**DRC**

**PZ20-12000009**

**3/3/2021**

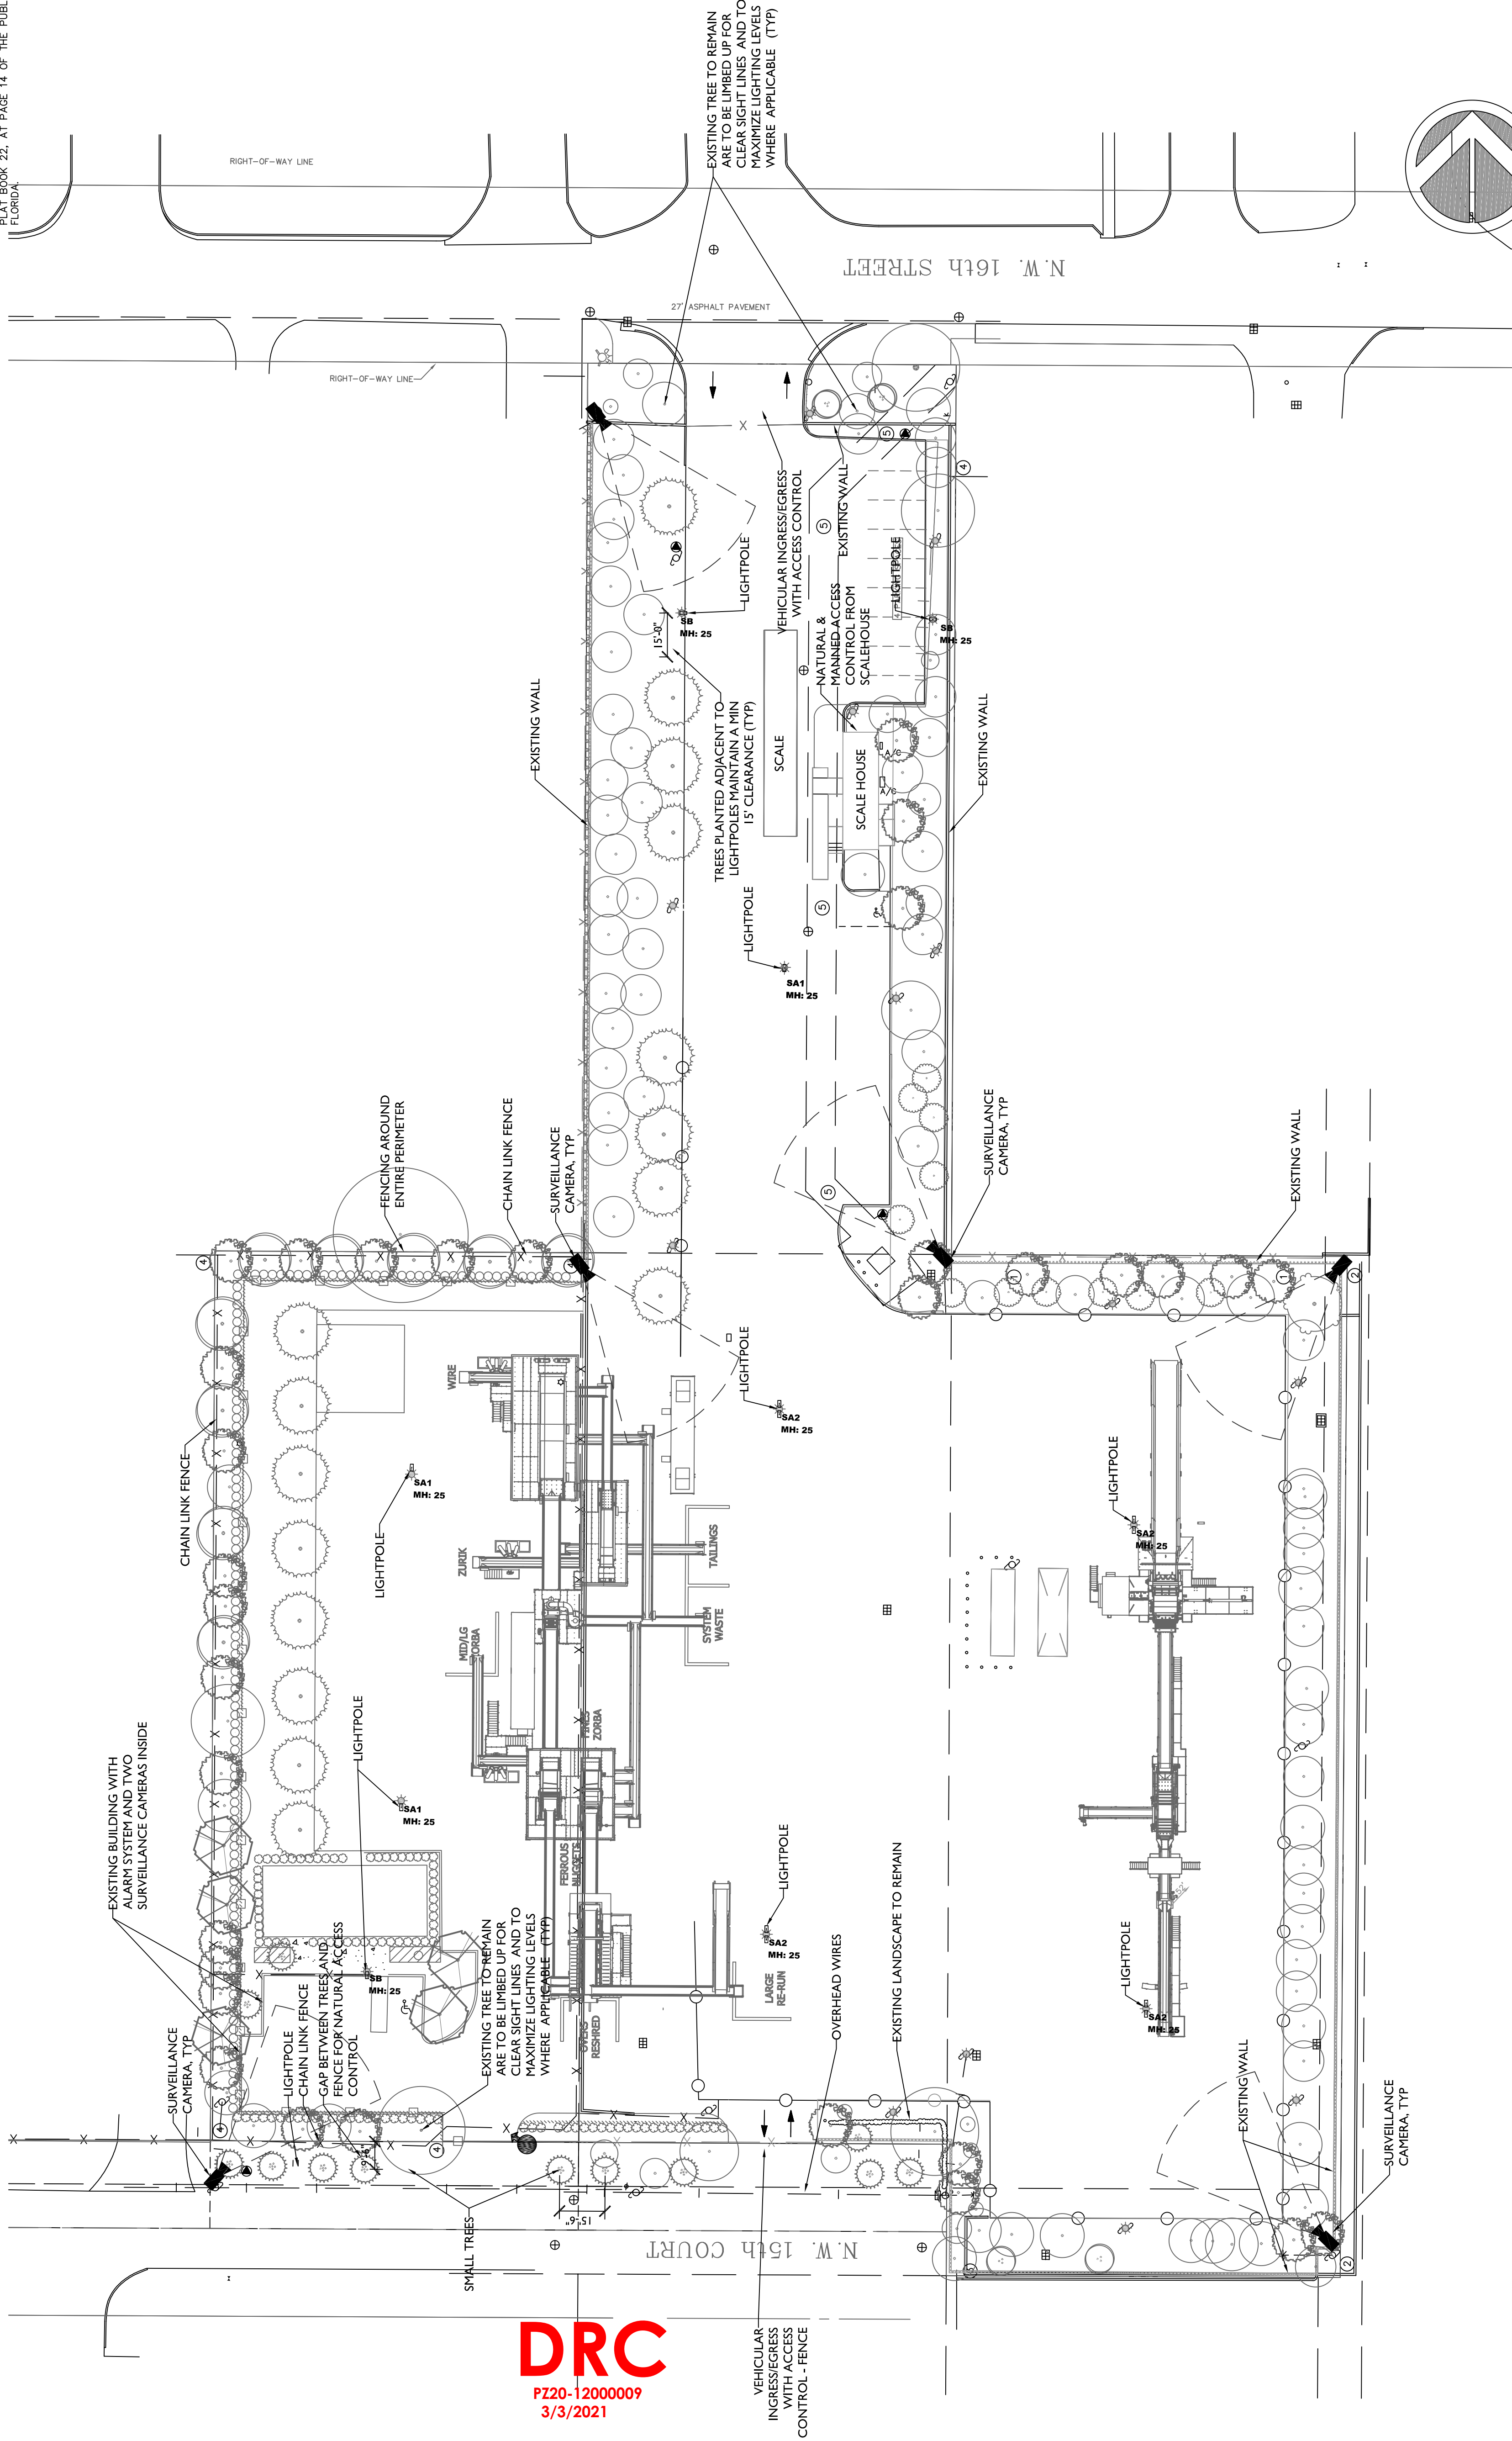
- a. Ensure electronic surveillance cameras and monitors are strategically located for maximum active and passive observation. Show sight "cones" indicating comprehensive coverage.

d. Security cameras must fully view all parking areas, building entrances and pedestrian paths of travel along the building perimeters.

g. Install motion activated security cameras on the perimeter boundaries, and the parking areas, and activity areas such as exterior amenity areas.

h. Install video surveillance along the exterior of the property facing the adjacent sidewalks and streets to deter criminal activities such as burglary, auto-theft, robbery, sexual assault & battery, etc.

**RESPONSE: Electronic surveillance cameras and their cone of view are shown on the updated CPTED Plan, and clearly shown on a mark-up attached to this response.**

**RESPONSE: Electronic surveillance cameras and their cone of view are shown on the updated CPTED Plan, and clearly shown on a mark-up attached to this response. All the building, parking and pedestrian areas will be covered.**

**RESPONSE: Electronic surveillance cameras and their cone of view are shown on the updated CPTED Plan, and clearly shown on a mark-up attached to this response. The perimeter boundaries, building, parking and pedestrian areas will be covered.**

**RESPONSE: Electronic surveillance cameras and their cone of view are shown on the updated CPTED Plan, and clearly shown on a mark-up attached to this response. Electronic surveillance will be provided on both the interior and exterior sides of the wall perimeters by NW 15<sup>th</sup> Court and NW 16<sup>th</sup> Street.**
